MECKLENBURG COUNTY
HEALTH DEPARTMENT

SOIL/SITE EVALUATION
for ON-SITE WASTEWATER SYSTEM

IMPROVEMENT PERMIT DENIAL

Re: Application for Improvement Permit for property located at 4509 WOODLAND AV , MINT HILL, NC 28227
Parcel No.: 13711270
Health Department File No.: SP26-097

PROPOSED PLOT PLAN

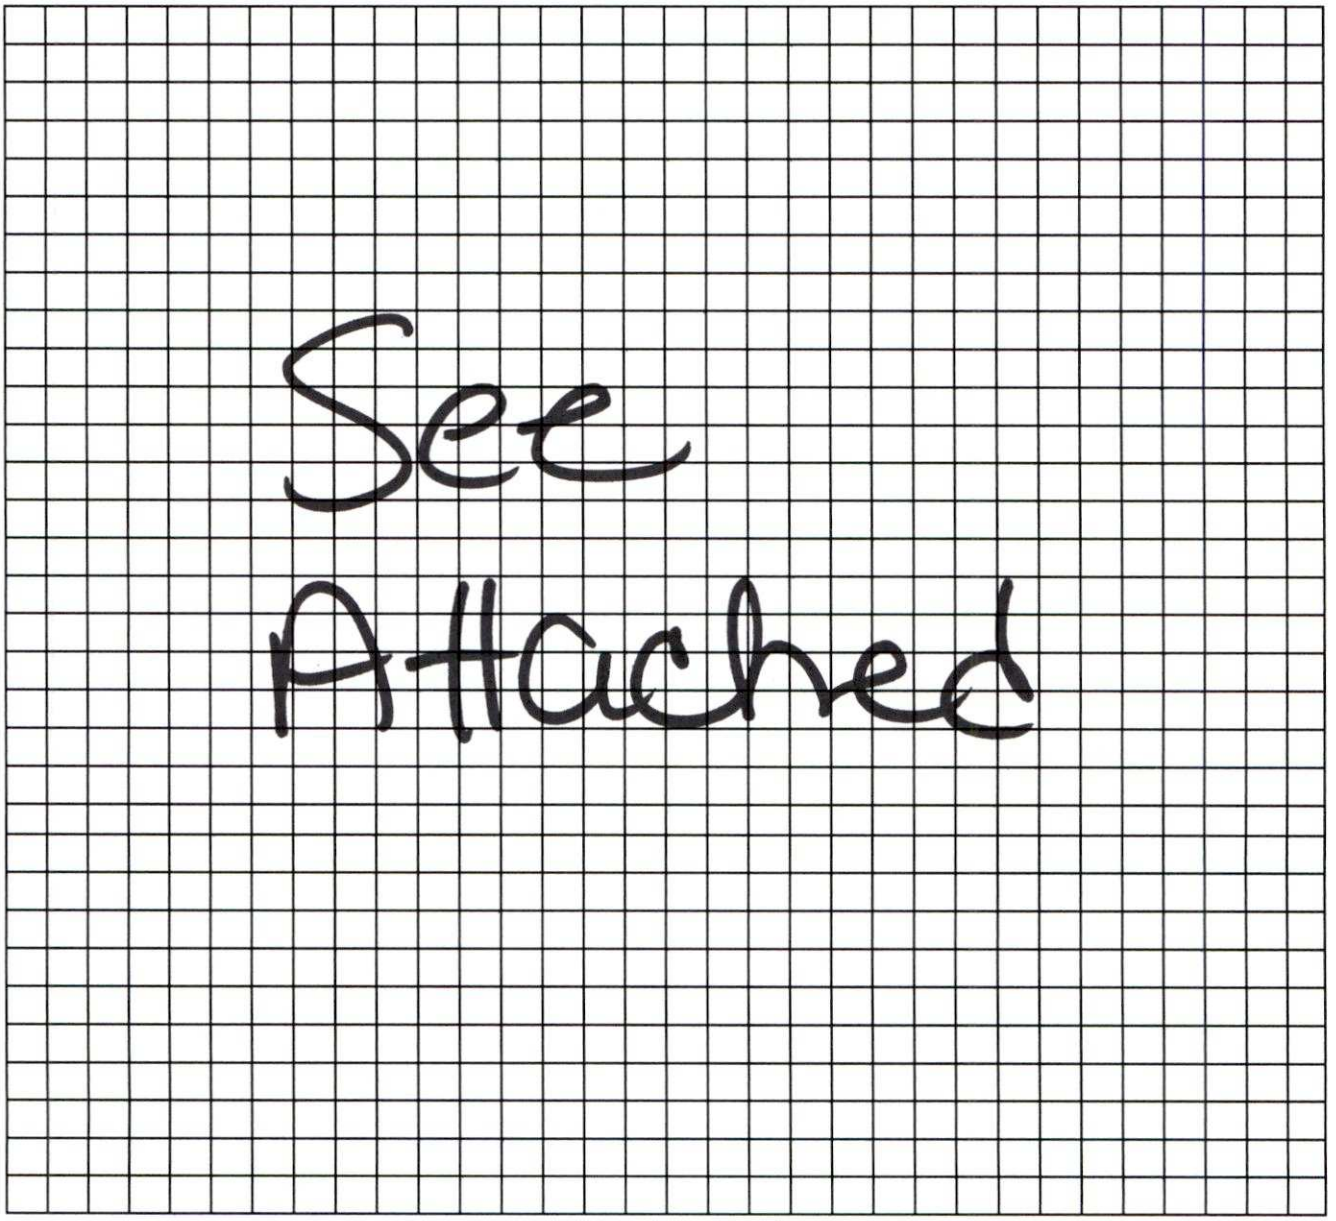
COMMENTS: There is insufficient space for a 5 BR SFR initial system and repair area with a design LTAR of 0.30.

Based on the criteria set out in 15A NCAC 18E .0501 through .0602, the evaluation indicated that the site is **UNSUITABLE** for an on-site wastewater system. Therefore, we must deny your request for an Improvement Permit. A copy of the site evaluation is enclosed. The site is unsuitable based on the following:

The site evaluation included consideration of possible site modifications, as well as use of all possible systems approved under 15A NCAC 18E. However, the Health Department has determined that none of the above options will overcome the severe conditions on this site. A possible option might be a system designed to dispose of sewage to another area of suitable soil such as off-site to additional property.

A site classified as UNSUITABLE may be classified as SUITABLE if written documentation is provided that meets the requirements of Rule .0509(b) or (c). A copy of this rule is enclosed. You may hire a consultant to assist you if you wish to try to develop a plan under which your site could be reclassified as SUITABLE.
